COMMONWEALTH OF VIRGINIA
COUNTY OF HENRICO

RE: POD2022-00098
Coca-Cola Bottling Co - Warehouse
Building Expansion
POD
Original Plan Review Comments

The Planning Department has completed its review of the above-referenced plans, received March 8, 2022, and has the following comments:

15. C401

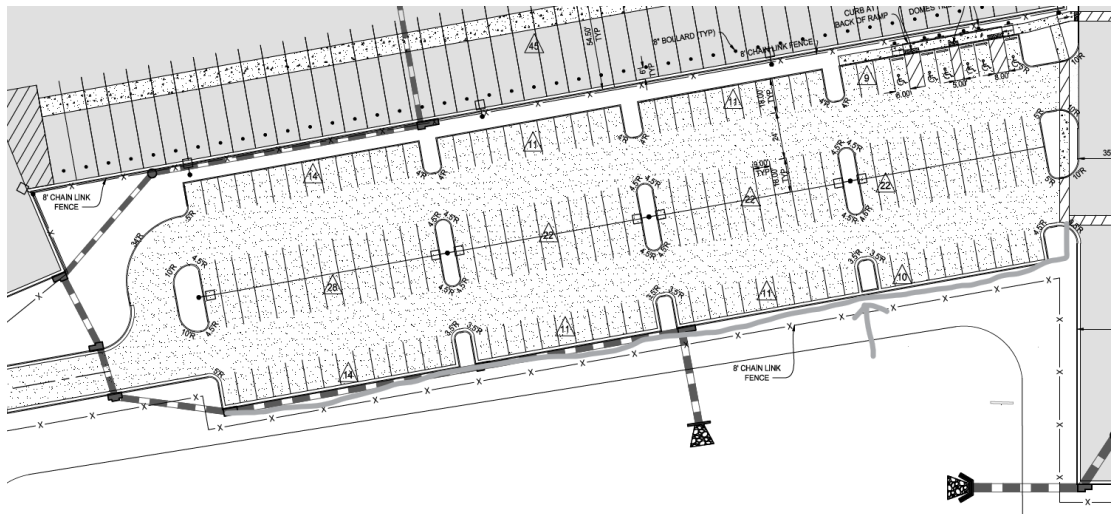
16. Can a line of sidewalk be added to provide safe pedestrian passage for employees to and from the parking lot? See below. The fence could be moved further south to provide the required 5' width for the sidewalk.

17. Provide details for the various gates proposed.

18. How is the guard shack access? There is no sidewalk to it.

19. Any thoughts to providing sidewalk to the tractor trailer parking areas?

26. C700

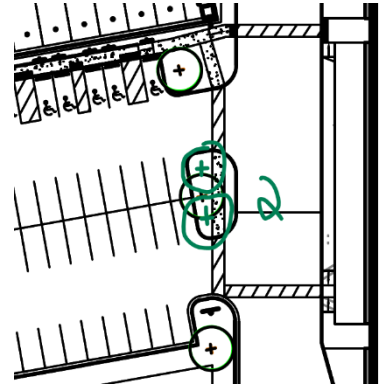
27. Add the orange, snow fencing style tree protection with 100' of the ROW.

28. Add a detail for the orange, snow fencing tree protection fencing.
